TRANSMITTAL	TRANSMITTAL NO. KC-RES-05-T01	DATE October 2026	SENT VIA Link · PDF attachment	PACKAGE 9 forms + appendix
--------------------	----------------------------------	----------------------	-----------------------------------	-------------------------------

Re: MEP technician / MEP modeler roles, and coordinator roles where they fit. Enclosed is my BCIT residential MEP model, the QA review I ran on it against BC code, and the drawings.

DESIGN REVIEW SUMMARY			ENCL. 03	PROJECT KC-RES-05	REVIEWED BY K. Chow	PERIOD 28 Sep - 2 Oct 2026
SUMMARY I reviewed my BCIT residential MEP model against BC code before issue. 51 issues across seven disciplines: 39 closed, 6 closed with placeholder families pending manufacturer content, 3 kept by design with reasons, 2 documented, 1 open. Every change was backed up, clash-checked and logged.						
ISSUES BY DISCIPLINE AND STATUS				QA PROCESS, PER ISSUE		
DISCIPLINE	CLOSED	PLACEHOLDER FAMILY	KEPT	DOCUMENTED	OPEN	TOTAL
HVAC	12	3	-	-	-	15
Plumbing	7	2	1	-	-	10
Electrical	7	-	-	-	-	7
Fire protection	3	1	1	1	-	6
Architectural	4	-	-	1	-	5
Fire alarm	3	-	-	-	1	4
BIM standards	3	-	1	-	-	4
Total	39	6	3	2	1	51
				MINOR FIXES		
				System classifica

ITEM NO.
C-03

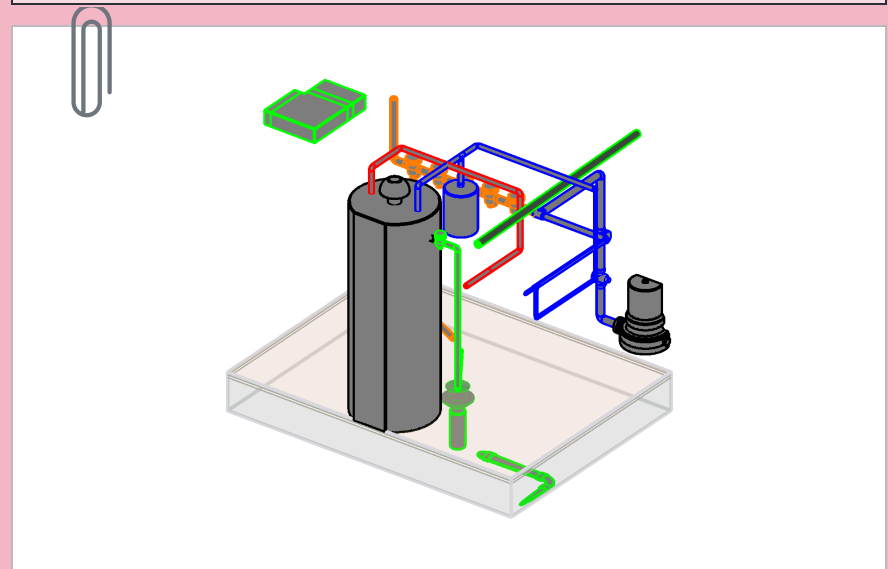
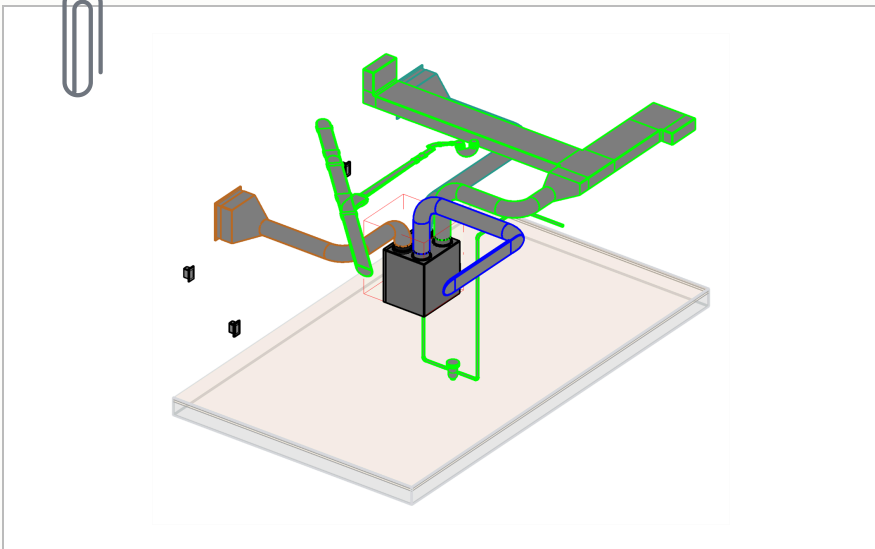
SUBJECT **Fire sprinkler main fed straight off domestic water**

The 1¼" sprinkler main teed off the domestic cold water through a transition fitting. No backflow preventer, control valve, gauge or drain & test.

No way to isolate, test, or stop stagnant sprinkler water flowing back into drinking water.

First build order: CV → BFP → PG → D&T → FS. A flow test would never pass the switch.

Five in-line placeholders on the fire main in the basement, with the drain & test discharging over the floor drain, in the order shown under After.

I placed the flow switch upstream of the drain & test valve. A flow test has to move water past the switch, or it can't prove the alarm works. Tracing where the test water goes showed the first order was wrong, so I swapped the two.

DCW tee → CV → BFP → PG → FS → D&T → up

Opening the drain & test now sends water through the flow switch first, so the test proves the alarm.

ITEM NO.
M-09 · M-10

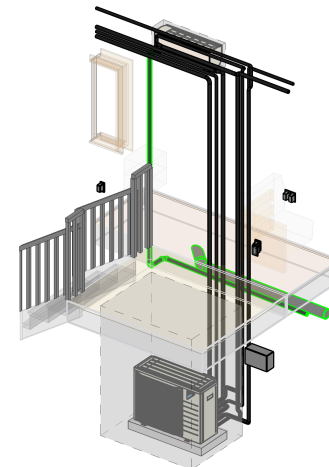
SUBJECT **Heat-pump sizing and the R32 charge limit**

No CSA F280 calculation. The living room's 2.0 kW head served a 35 m² room with a 5.9 m vault. The heads were cooling-only, so the house had no real heat.

AC-04 FTC20: **2.0 kW** against an open-zone cooling load of **3.3 kW**.

All four heads FTC, cooling only. Heat came from the backup baseboards added in C-01.

Option A, recorded as a deviation from the BCIT equipment spec (FTC15NV14 × 3 + FTC20NV14). Then checked the R32 charge against the smallest room.

I chose heat-pump heads over adding 2.3 kW of baseboard, knowing it departs from the coursework equipment. One system heats and cools, the panel stays within its rating, and heating uses about a third of the electricity. I then checked the R32 charge against the smallest room, because a multi-split can leak its whole charge into one bedroom.

F280-STYLE ESTIMATE house 3.6 kW heat / 4.6 kW cool

HEADS FTX15 × 3 + FTX35

LIQUID LINES 18.9 + 5.8 + 8.9 + 22.3 = 55.9 m

CHARGE 2.0 + (55.9 - 30) × 0.02 = **2.5 kg**

m_{max} (Bedroom 1) 2.5 × 0.307^{1.25} × 1.8 × √7.44 = **2.80 kg**

RESULT 2.5 ≤ 2.80, passes with no mitigation

ITEM NO.
M-12

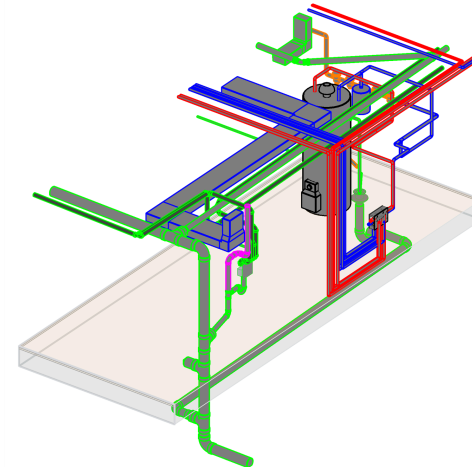
SUBJECT **A pipe through the water heater, and no floor drain**

A 1" PVC pipe hung off the water heater's drain-valve connector with its centreline inside the tank wall. Its comment said it was the T&P discharge. The basement had no floor drain for it.

1" PVC on the tank's **drain valve**, clipping the tank. PVC is not rated for 99 °C relief water.

No floor drain; building drain exit only 0.14 m below the floor.

Deleted the pipe; added a real T&P valve with a $\frac{3}{4}$ " copper discharge; floor drain FD-01 with a P-trap, 3" drain at 2 % to a new sanitary tee; stack extended from -2.19 to -2.95 m.

I removed a PVC relief pipe that ran through the tank wall and gave the T&P valve a full-size copper discharge to a new trapped floor drain. I extended the building drain stack so the drain works by gravity, without a sump pump.

WH-01 → TPV-01 → $\frac{3}{4}$ " Cu → air gap → FD-01 → P-trap → stack

Trap seal about 95 mm; trap seal primer noted on FD-01.
